Access Compliance Report

(Curb Ramps)

Intersection ID: 10019039	Main Street: KELSEY_WOODS_CT	Cross Street: N/A	Location: SW
ADA ID: CDA0A357EF81	Ramp Type: BlendTrans1	Initial Pass/Fail: Fail	Overall Compliance: No
Codes/Mitigation Info/Possible Solution		Field Measurements/Component Compliance	
Severity Score: 8.75

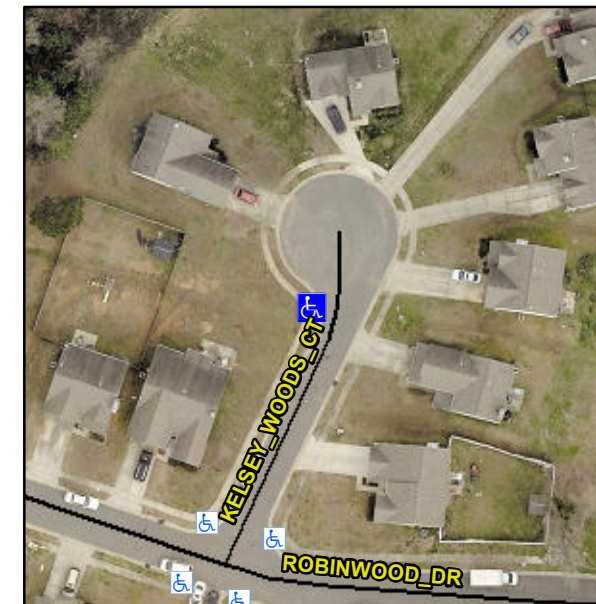
Not Found, R304.5.1

Compliance	Description	Data	Compliance	Description	Data
N/A	Ramp Length (in)	47.0	Yes	BlendTrans Slope (%)	4.2
No	Ramp Width (in)	47.0	Yes	BlendTrans XSlope (%)	0.6
N/A	Flare Type LT	N/A	N/A	Flare Type RT	N/A
N/A	Flare Slope LT (%)	N/A	N/A	Flare Slope RT (%)	N/A
N/A	Flare Traversable LT?	N/A	N/A	Flare Traversable RT?	N/A
N/A	Landing Length (in)	N/A	N/A	DWS Provided?	N/A
N/A	Landing Width (in)	N/A	N/A	DWS Contrast?	N/A
N/A	Landing Slope (%)	N/A	N/A	DWS Length (in)	N/A
N/A	Landing X Slope (%)	N/A	N/A	DWS Full Width?	N/A
N/A	Landing Curb? (Y/N)	N/A	N/A	DWS Offset (in)	N/A
N/A	Shared Landing?	N/A			
N/A	Gutter Ponding?	N/A	N/A	Gutter Slope (%)	N/A
N/A	Gutter Lip Ht (in)	N/A	N/A	Gutter X Slope (%)	N/A
N/A	Painted X Walk1?	No	N/A	Painted X Walk2?	N/A
	X Walk 1 Direction	To E		X Walk 2 Direction	N/A
	X Walk 1 Width (in)	N/A		X Walk 2 Width (in)	N/A
	X Walk 1 Slope (%)	2.0		X Walk 2 Slope (%)	N/A
	X Walk 1 X Slope (%)	0.3		X Walk 2 X Slope (%)	N/A

N/A	Ramp inside XWalk1?	N/A	N/A	Ramp inside XWalk2?	N/A
	Road Slope (%)	0.3		Clear Space?	N/A
	Road X Slope (%)	2.0	N/A	Clear Space to XWalk (in)	N/A
N/A	Any Obstructions?	N/A	N/A	Storm Grate/Utility Hazard?	N/A
	Obstruction Type			Storm Grate/Utility Type	
		N/A			N/A
			Yes	Surface Condition? (G/P)	Good
			No	Curb Slope (%)	9.8

Remove & Replace Curb Ramp With Two New Directional Ramps or Equivalent.
